ORGANIZATION AND ADMINISTRATION

OA-1 *Correct the typo in the first sentence of LA Section 2.1.2. This sentence indicates that the IIFP management owns and operates the plant.*

Figure 2-1 IIFP Project Design and Construction Organization

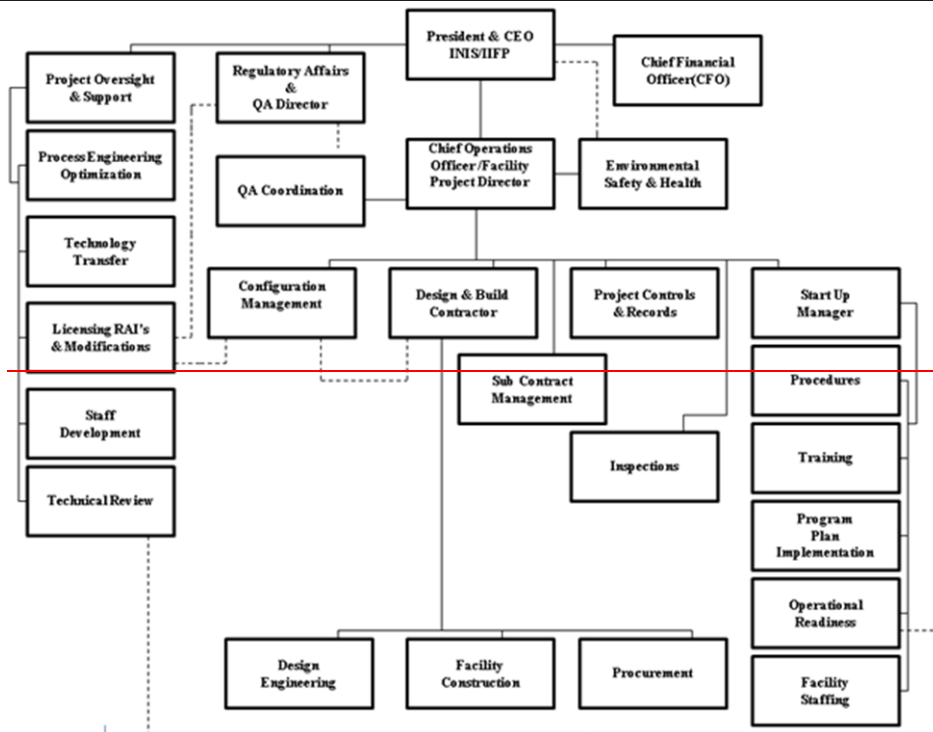
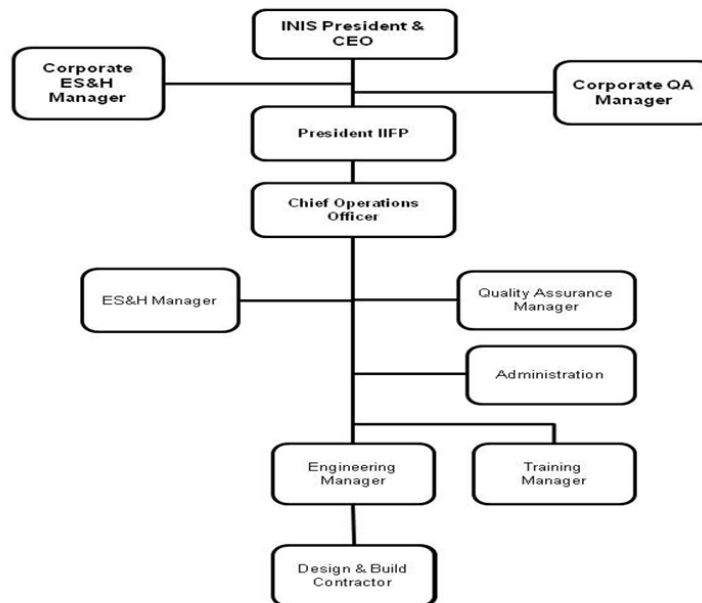
OA-7. *The organizational structures displayed in LA Figures 2-1 and 2-2 have a complex interconnectivity (“matrix structure”) which is not well defined in LA Sections 2.1.2 and 2.1.4. Consistent with NUREG-1520, Sections 2.4.3(1) and 2.4.3(2), provide the following information:*

- A. *To demonstrate a clear, unambiguous set of management controls and communications among organizational units, reduce the complexity of LA Figures 2-1 and 2-2 or expand the explanations in 2.1.2 and 2.1.4, or both. This may involve reducing the level of detail in the figures, focusing the explanation in the text to explain the groups responsible for the “design, construction, and operation of the facility [NUREG-1520, 2.4.3(1)],” removing or explaining dual reporting relationships, making the Figures layouts easier to read, etc. Any dual reporting listed in the Figures should be explained in the text.*

- C. *The application indicates that the COO has responsibility for the design, engineering, construction, startup, operation, maintenance, etc. However, the COO/Commercial Facility Project Director (CFPD) (Design/Build (DB) phase) is not at the top of the Figure 2-1; nor is the COO/Plant Manager (operations phase) at the top of Figure 2-2. In addition, several other groups are parallel or above the COO for both phases. Consistent with NUREG-1520 2.4.3(1), clearly indicate which individuals listed in LA Figures 2-1 and 2-2 are ultimately responsible for overseeing the design, construction and operation of the facility.*

RESPONSE: The matrix structure has been omitted from organizational charts (Figures 2-1 and 2-2) with the corresponding dual reporting text deleted in the LA Chapter 2 Revision B rewrite of Sections 2.1.2 and 2.1.4.

Revision A figure below is deleted and replaced with Figure 2-1 on following page

Figure 2-1 has been revised with the IIFP President at the top of the IIFP organization and the highest authority within IIFP. The IIFP President reports to the parent corporation INIS President/Chief Executive Officer. The other management individuals in the parent corporation that interrelate with the IIFP President are the Corporate ESH Manager and the Corporate QA Manager. These parent corporate staff managers interrelate with the IIFP President by assisting the IIFP COO and providing support to the IIFP ESH and QA management (See Section 2.2.2 of the IIFP LA Chapter 2 Revision B attached). The COO reports directly to the IIFP President and as such is delegated the line organization authority for the responsibility of managing the administration, ESH, QA, engineering, training and supporting contractor functions during the licensing, design and construction of the IIFP Facility. Once the IIFP Engineering Manager is hired the COO will assign responsibilities and delegate authority to the Engineering Manager, who reports to the COO, for providing design authority and direct oversight of the Design and Build Contractor and for ensuring professional and contractor support is in place to perform any required Integrated Safety Analysis and licensing documentation.

Section 2.1.2 of the IIFP LA Chapter 2, "IIFP Design and Construction Organization Structure" addresses the organization structure during the DB phase of the IIFP Project. Figure 2-1 addresses that organizational structure. The roles and responsibilities of individual positions in managing the design, construction and operation of the facility are discussed in response to RAI OA-7A above.

Figure 2-2 Plant Operation Organization

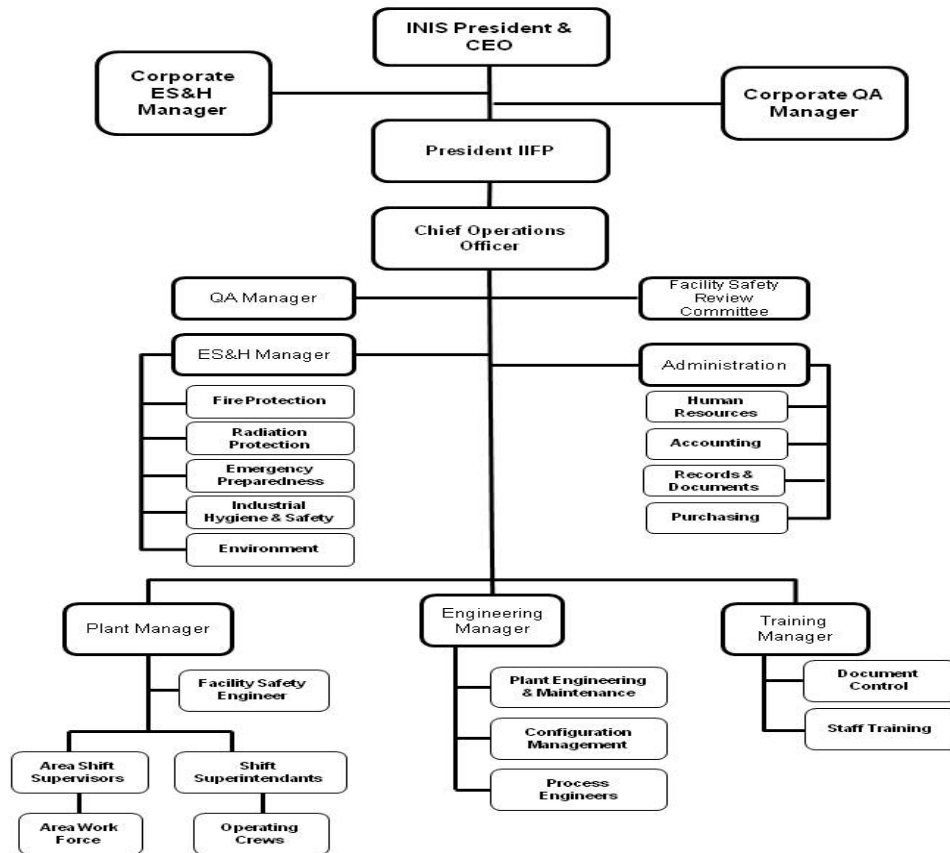
- C. *The bulleted list in Section 2.1.4 on Pages 2-5 and 2-6 appears to match positions listed in LA Figure 2-2. Ensure that the management positions listed in Figure 2-2 match the positions contained in the bulleted list.*

- B. *The second full paragraph of LA Section 2.1.3 indicates that the ESH reports to a different manager after the transition from the DB phase to the Operations phase. Based on LA Figures 2-1 and 2-2, the entire management structure changes during this transition. Consistent with NUREG-1520, Section 2.4.3(4), clarify why only the ESH is called out specifically in Section 2.1.3; and describe the transitions for all key managers. Also, introduce new key organizations created for the Operations phase and provide a description of the new positions in LA Section 2.2. Provide an overview of how the positions listed in Figure 2-1 will be transitioned to the positions in Figure 2-2, similar to the description provided for the COO.*

RESPONSE: The organizational chart for the Plant Operation Organization of the IIFP (Figure 2-2) has been revised to replace the position of the RAQD with both a Corporate QA Manager and a Corporate ESH Manager reporting to the INIS President and CEO. The responsibilities for these corporate positions are provided in Section 2.2.2.of the attached rewrite (Revision B) of the IIFP LA Chapter 2.

The revised Figure 2-2 shows the same organizational structure during the plant operations phase. A position of Plant Manager reporting to the COO was added to the Plant Operation Organization chart. The responsibilities for the Engineering Manager, the COO, the Plant Manager, and the IIFP President are delineated in Section 2.2, "Key Management Positions, Responsibilities, and Qualifications."

RESPONSE: The subject bulleted list does not include all the positions listed in Figure 2-2. It has been revised to include the IIFP Facility functions where the IIFP COO provides leadership and responsibility.
